Re: Public Comment Letter for Scott River Valley Draft Groundwater Sustainability Plan

Specific Comments on the Scott River Valley Draft Groundwater Sustainability Plan

Comments on the Scott Groundwater Sustainability Plan

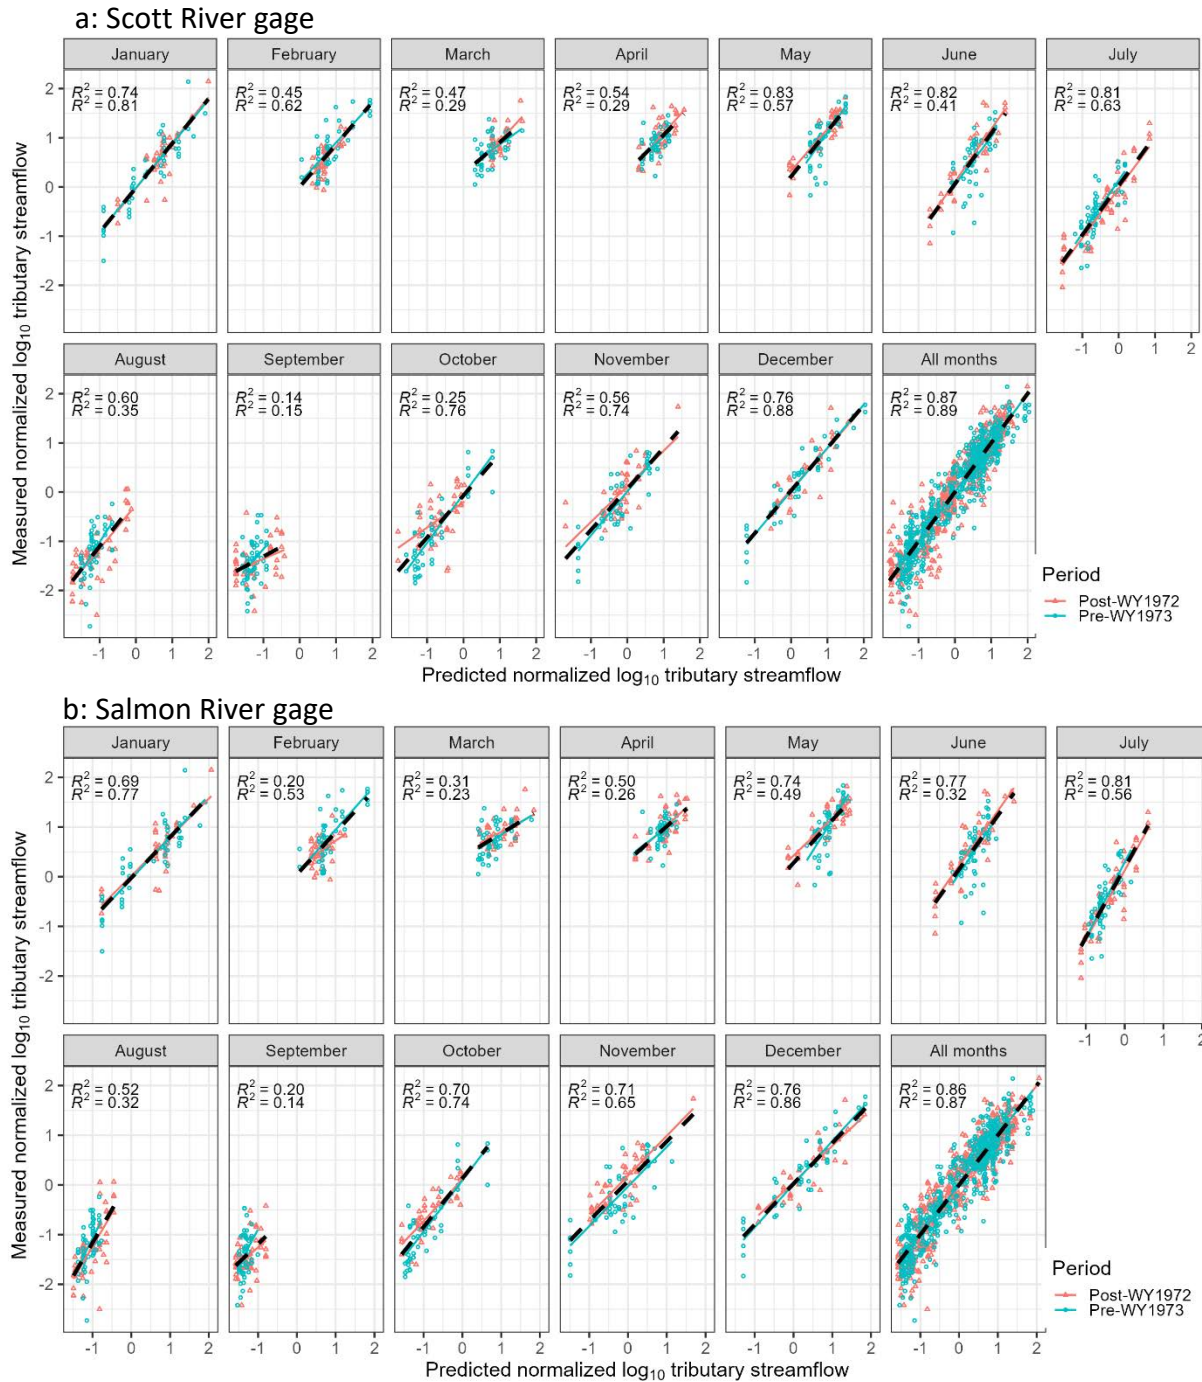
In contrast to the major differences in the relationships between tributaries flows and Scott River flows for the WY 1957–1972 and WY 1973–2016 periods (Figure 1a), there appears to be no difference between the periods when the Salmon River gage is used instead (Figure 1b). The lack of difference between these periods in the Salmon River models suggests that for tributaries that have no post-1972 flow data (i.e., Shackelford, Patterson, Moffett, and Etna creeks)(Figure 2a), it is likely better to use of Salmon River models for gap-filling additional months (i.e., maybe June–December for these tributaries, instead of the September–November we are recommending for the other tributaries?). The recommendation for June–December is based on the observation that the between-period divergence occurs at normalized \log_{10} Scott River flows less than zero (Figure 1a) and in the WY 1973–2016 period such flows tend to occur more frequently in June–December than other months (Figure 4a).

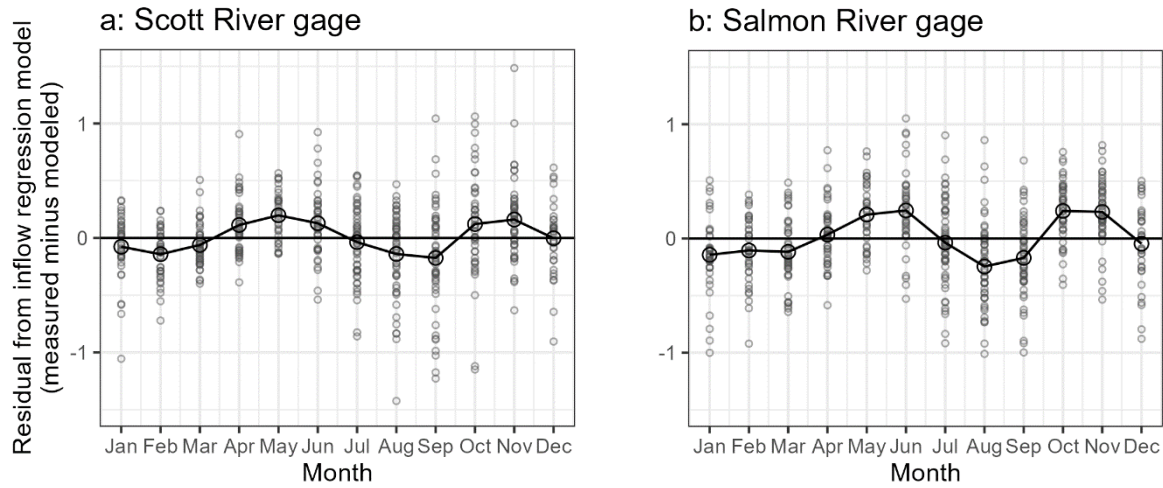
One additional suggestion for potential additional refinements to the methods for filling data gaps that we do not currently have time to test, but want to mention here so it could potentially be followed up on later, is to use hierarchical models and account for watershed area. The SVIHM's normalization (a.k.a. "standardizing", our preferred term) of the flow data (subtracting the mean and dividing by standard deviation, with the mean and standard deviation calculated individually for each site based on that site's period of record) is intended to allow all tributaries to be included together in the same regression model. However, we have some concerns that for sites with short records (e.g., 11 months at Mill Creek, 6 months at Etna and Patterson creeks), there are far too few data points for the mean and standard deviation to be representative of long-term patterns, which could lead to artifacts in the regression outputs. A possibly more robust alternative would be to instead convert the flow data to specific discharge (i.e., flow per watershed area in units of cfs/mi² or its metric areal equivalent mm/d), then standardizing by subtracting the mean and dividing by standard deviation (with the mean and standard deviation calculated from the entire pool of specific discharges from all sites, rather than calculating the mean and standard deviation only from each site's period of record). From these standardized specific discharges, a single hierarchical model (a.k.a. mixed effects model) could be constructed with appropriate random effects to explicitly account for inter-site differences. R packages available for implementing such models include 'mgcv', 'lme4', and 'nlme'. A hierarchical model could help account for inter-site differences. For example, not surprisingly given its the relatively low elevation watershed, Moffett Creek appears to have a greater percent of its annual flow occur during January–March than other tributaries and then a lesser percent of its annual flow occurs during May–June snowmelt runoff (not shown here). There are clear, albeit relatively small, seasonal patterns in the residuals (calculated as measured minus modeled) in both the Scott River and Salmon River regression models, with both models under-predicting tributary flows in May–June and October–November and over-predicting tributary flows in January–March and August–September (Figure 5). A hierarchical model would likely help remove the seasonal patterns in model residuals.
